**PLANNED UNIT DEVELOPMENT
& SUBDIVISION STAFF REPORT****Date: January 21, 2021****DEVELOPMENT NAME**

Springdale Mall Subdivision – Phase II

LOCATION3250 Airport Boulevard and 325 East I-65 Service Road South
(Northeast corner of Airport Boulevard and East I-65 Service Road South).**CITY COUNCIL
DISTRICT**

SITE PLAN

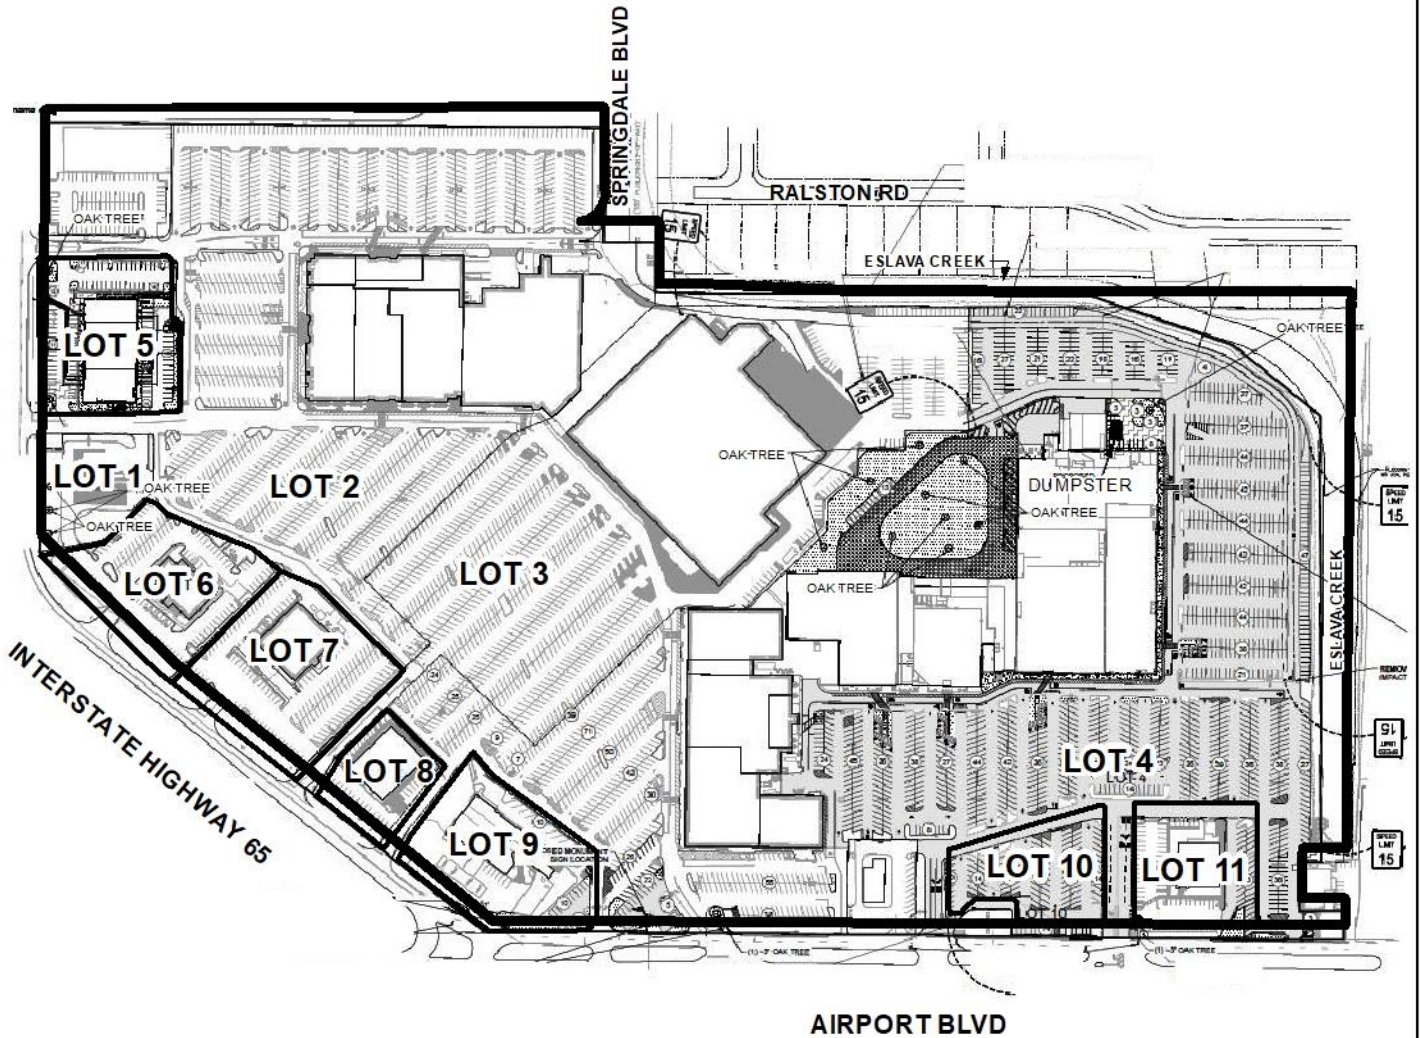
**ENGINEERING
COMMENTS****Subdivision:** No PLAT was submitted for review.**Planned Unit Development:** Retain NOTES #3 - #8, as shown on the OVERALL SITE PLAN drawing SHEET C1.3 dated 4-28-2020.**TRAFFIC ENGINEERING
COMMENTS**

No plat was submitted as part of the subdivision request, but staff utilized the PUD site plan to determine the site's compatibility with the Subdivision Regulations. A subdivision plat will be required for final approval of the request, per Section IV.C. of the Subdivision Regulations.

Lot 3 on the PUD site plan is not included in the subdivision application. Additionally, the existing lots to the west of Lot 10 and the existing lots at the northwest corner of Lot 2 are not included in the subdivision as they are existing legal lots of record. These lots are, however, included in the PUD application due to the cross access.

Due to the previous subdivision applications, existing rights-of-way are likely compliant. The Final Plat and site plan should be revised to either depict compliant rights-of-way or depict dedication to bring them into compliance.

Lots 2, 3, and 4 are irregular in shape and may be considered panhandle or flag lots, and each have frontages that cause them to exceed the maximum width-to-depth ratio as outlined in the Subdivision Regulations. Such designs are generally discouraged by Sections V.D.1. and V.D.3. of the Subdivision Regulations, respectively, the exception being the approval of lots located where varied and irregularly shaped lot designs are common, and the informality of design is consistent with other lots in the vicinity. Previous subdivision approval of the site with lots of similar designs may justify approval of the request at hand, but waivers of Sections V.D.1. and V.D.3. will be required.

Each lot appears to satisfy the minimum size requirements of the Subdivision Regulations for lots served by public water and sanitary sewer systems; however, staff cannot verify this information as the site plan does not provide the sizes of the proposed lots. If approved, the required subdivision plat should provide the sizes of each lot in both square feet and acres, either as a label for each lot, or in a table on the plat.

The minimum building setback line is not illustrated on the site plan. The plat will be required to depict the required 25' minimum building setback line along each frontage where the lot is a minimum of 60' wide. The site plan should also be revised to illustrate the required 25' minimum building setback.

Multiple easements exist on the property, but are not illustrated on the site plan: a 10' sanitary sewer easement through Lots 1, 2, 3, 4, 10, and 11; a 10' water line easement along the frontages of Lots 4, 10, and 11; a drainage easement of varying width along the East property line of Lot 4; a 10' Mobile Area Water and Sewer Board easement through Southern portions of Lot 4 and Lot 11; a 20' water line easement through a Western portion of Lot 4, and Eastern portions of Lots 2 and 3; an Alabama Power Company easement of unknown width adjacent to the 20' water line easement; an Alabama Power Company easement of unknown width along the North property lines of Lots 3 and 4; an Alabama Power Company easement of varying width in the Northwest portion of Lot 3 and along the East property line of Lot 2; a drainage easement of unknown width along the East property line of Lot 2; a 75' Alabama Power Company easement near the North property line of Lot 2; and a 10' water and sewer easement along a portion of the West property line of Lot 2. Also, a 100' right-of-way was granted to Alabama Power Company and runs from the Southeast corners of Lots 4 and 11 to the North property line of Lot 4. All easements and the Alabama Power Company right-of-way should be illustrated on the Final Plat, and a note should be placed on the plat stating no structures shall be constructed or placed within any easement without permission of the easement holder.

The site plan does not provide the specifications for Final Plat approval regarding the general form, information to be shown, or attendant items required by Section IV.C. of the Subdivision Regulations. Such requirements include the items, notes, and certifications that should be placed on a subdivision plat. As such, the Final Plat should provide all the information required by Section IV of the Subdivision Regulations, along with any additional information required by the Engineering Department, if approved.

Demolition of a portion of the multi-tenant building on Lot 4 previously used as a movie theater, as well as part of a previous expansion of the same building, to the East, is proposed. Also, a six (6)-lane drive-thru for a former bank on Lot 4 is proposed to be reduced to one (1) lane, which will be relocated to the North of the building.

Full compliance with tree planting and landscape area ordinances is not required as a result of the proposed demolition or increase in parking, but the May 21, 2020 approval of the PUD required five (5) additional over-story tree plantings along the East I-65 Service Road frontage, and where open space was created by the proposed site modifications. The site plan illustrates compliance with these requirements.

A new dumpster pad is proposed to be constructed to the rear of the largest tenant space on Lot 4. No additional information regarding the dumpster pad was submitted with the PUD plan. Any dumpster placed on the property shall be in compliance with the current enclosure and sanitary sewer connection requirements of Section 64-4.D.9. of the Zoning Ordinance.

- 1) Provision of a subdivision plat compliant with Section IV.C. of the Subdivision Regulations;
- 2) Either depiction of existing, compliant right-of-way widths along East I-65 Service Road and Airport Boulevard, or dedication thereof;
- 3) Provision of the sizes of each lot in square feet and acres on the Final Plat, or provision of a table on the Plat with the same information;
- 4) Depiction of the required 25' minimum building setback line along all street frontages where the lots exceed 60' in width;
- 5) Depiction and labeling of all existing easements and the Alabama Power Company right-of-way;

- 6) Placement of a note on the Final Plat stating that no structure may be constructed or placed within any easement without the permission of the easement holder, if applicable;

- 1) Compliance with Engineering comments (*Retain NOTES #3 - #8, as shown on the OVERALL SITE PLAN drawing SHEET C1.3 dated 4-28-2020.*);
- 2) Placement of a note on the site plan stating Traffic Engineering comments: (*Applicant has performed a Traffic Impact Study (TIS) and has arrived at several recommendations that are acceptable to Traffic Engineering and have been included in the PUD site plan. Site is limited to the curb cuts as illustrated in the approved PUD with any changes in size, location, and design to be approved by ALDOT (where applicable) and Traffic Engineering and conform to AASHTO standards. All on-site parking, including ADA handicap spaces, shall meet the minimum standards as defined in Section 64-6 of the City's Zoning Ordinance.*);
